IMPORTANT SAFETY RECALL NOTICE

Subject Öhlins R&T Steering Damper kits	Date 2013-11-19	Page 1(3)
Author Göran Hedin	Distribution Steering Damper Owners

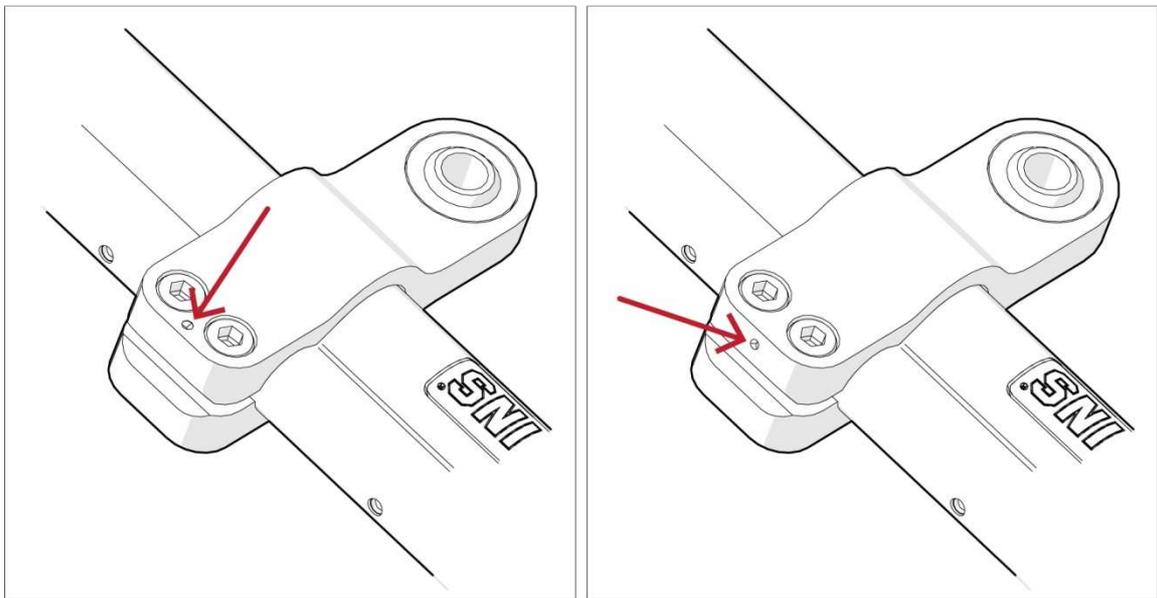
The cause is material being machined in an unfavorable direction in combination with probable material defect and the aluminum alloy being sensitive for stress corrosion cracking.

There is a risk if the bracket will fail, that the bracket can slide on the cylinder body resulting in less steering angle in one direction or possibly a sensation of uneven or asymmetric damping. Either of these events may surprise the rider in a way that the rider does not have full control of the motorcycle.

The material in question was produced by Öhlins Racing AB from September 2008 until October 2013 and this problem does no longer exist on steering dampers produced after this date. The replacement bracket will be easy to identify with a small dot either between the two small clamp screws on top or at the edge of the bracket (see pictures above).

We therefore ask you to remove the steering damper bracket and send it to us using the contact details below. We will receive new brackets for the steering damper that will rectify this problem.
